CITY of NOVI CITY COUNCIL

Agenda Item 3
March 11, 2013

SUBJECT: Approval of the request of Sun Vally, Ltd. for GFS Marketplace JSP12-71, for the Preliminary Site Plan, Special Land Use and Stormwater Management Plan. The subject property is located south of Twelve Mile Road and west of Donelson Drive in the RC, Regional Center District. The subject property is 2.15 acres and the applicant is proposing an approximately 16,000 square foot GFS Marketplace retail store at the Twelve Mile Crossing at Fountainwalk Shopping Center.

January 16, 2013
Planning Review
GFS Marketplace
JSP12-71

SITE PLAN / SUPPLEMENTARY LANDSCAPE PLAN

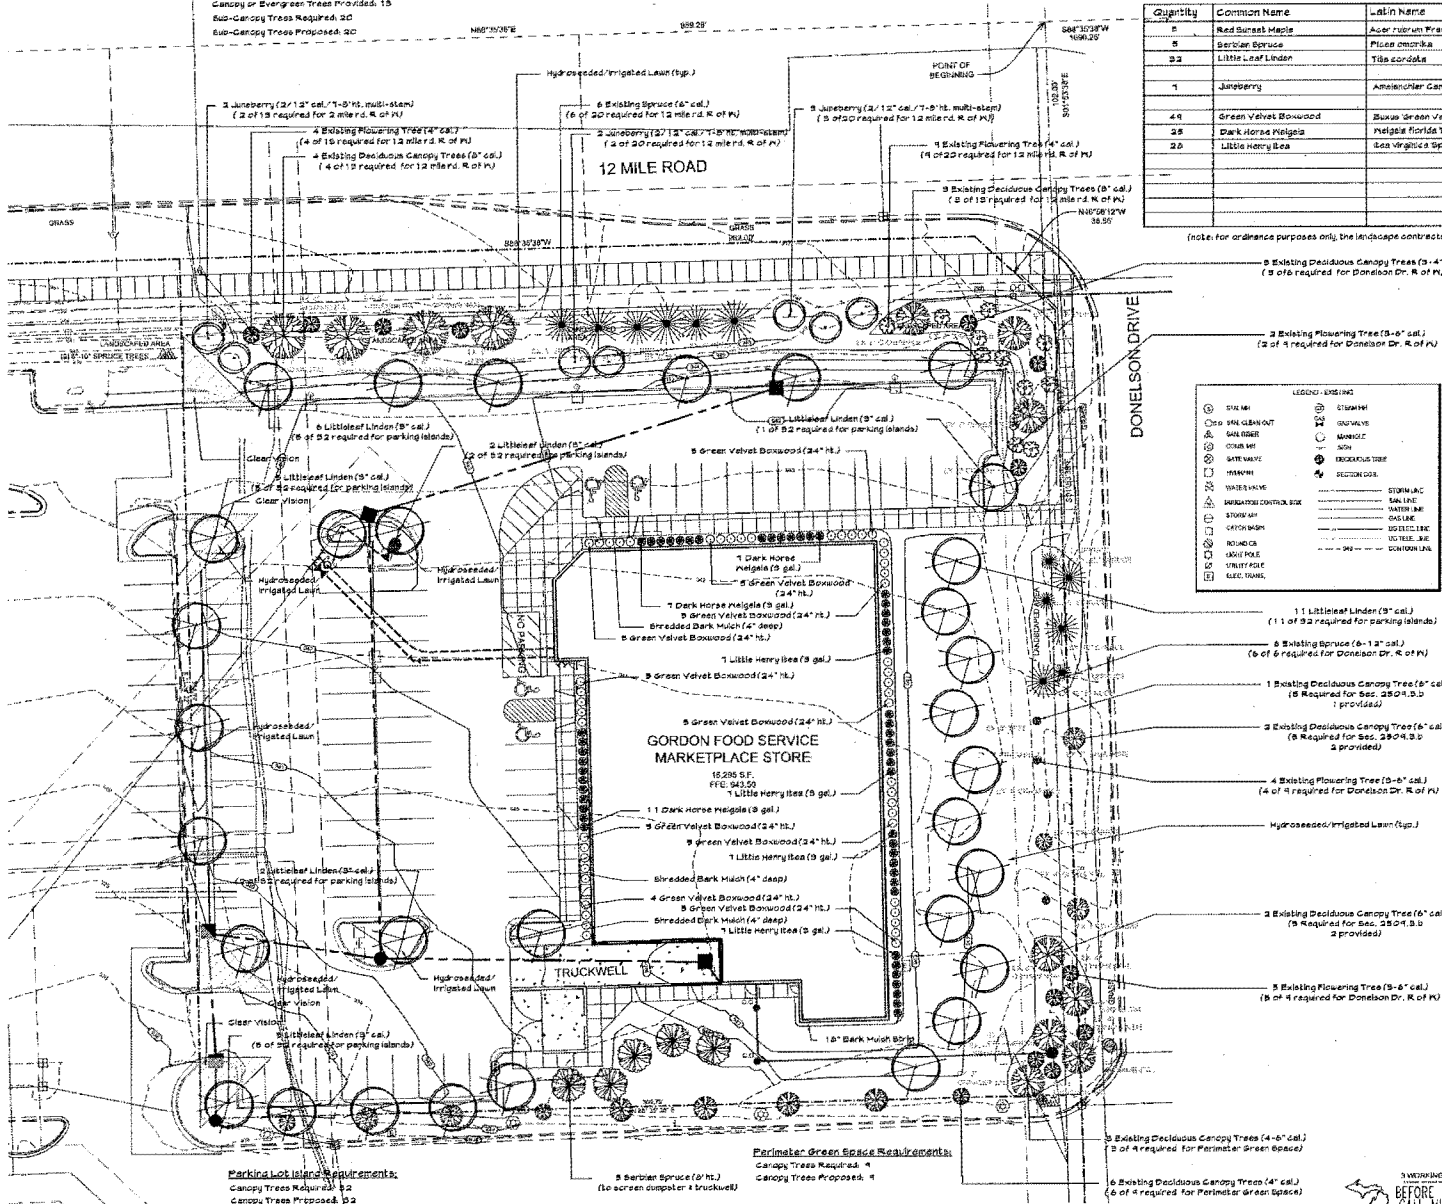
- d. Subject to Applicant providing an additional landscape island so that no more than 15 contiguous parking spaces are provided;
- e. With this City Council waiver to allow relocated foundation landscaping provided additional plantings are shown along the north and east sides of the building as indicated in the supplementary landscape plan provided;

than fifteen contiguous parking spaces would be required. Staff does not support this waiver and the applicant has indicated they will comply with the ordinance requirements. A waiver would also be required to allow the foundation landscaping to be relocated to another area of the site. The applicant has provided staff with a revised landscape plan showing additional landscaping on the east portion of the site. Staff finds the proposed additional landscaping to be acceptable and supports the requested waiver.

Alternative A: Flat Parking Surface with Sidewalk Ramped - Wheel Stops Not Required

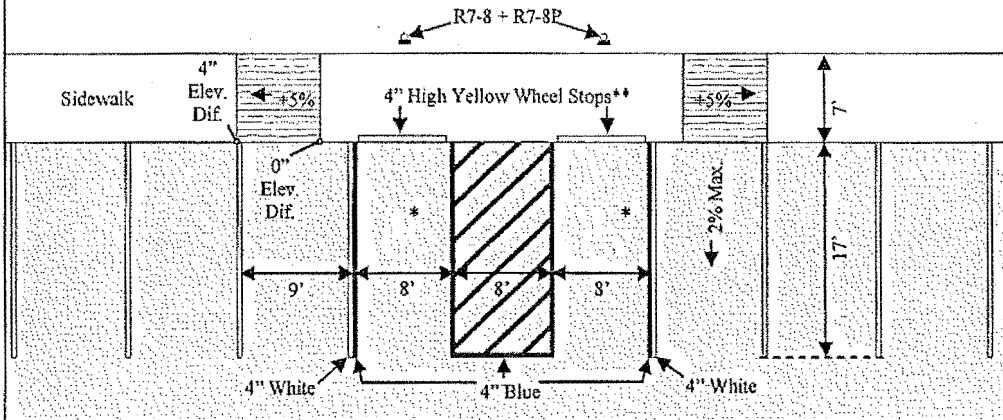
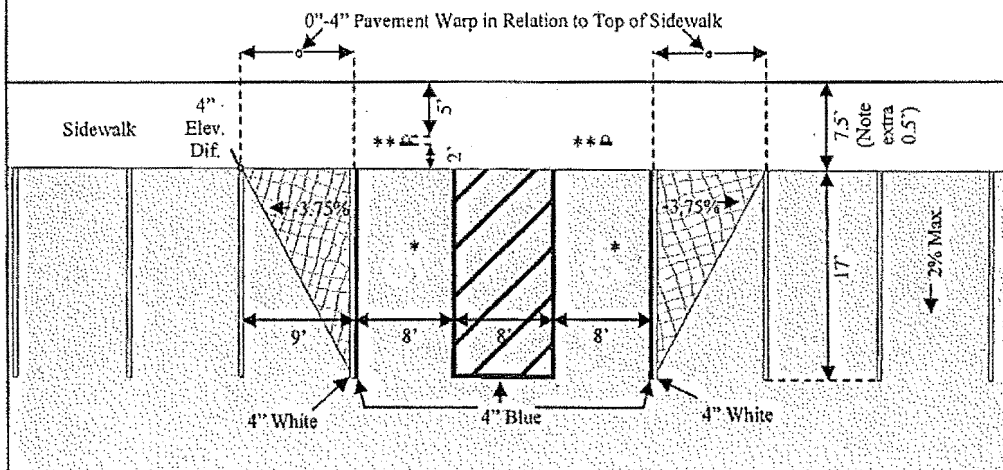
9. As requested, the sidewalk around the building has been widened to 7 ft; however, the adjacent parking spaces have been shortened only to 18 ft rather than the 17 ft requested; **the applicant should explain the need for the 1 ft of extra pavement (rather than landscaping behind the sidewalk).** Also, any space length less than 19 ft requires the sidewalk height to be limited to 4 inches (per Sec 2509.3.c(2)(c) of the Zoning Ordinance). Although we are unable to find any relevant elevation data in the plans, **it appears from a note on sheet C-103 ("Slope sidewalk down 6" so flush with bituminous pavement at striped aisle") that the sidewalk height is now proposed to be an unacceptable 6 inches.**
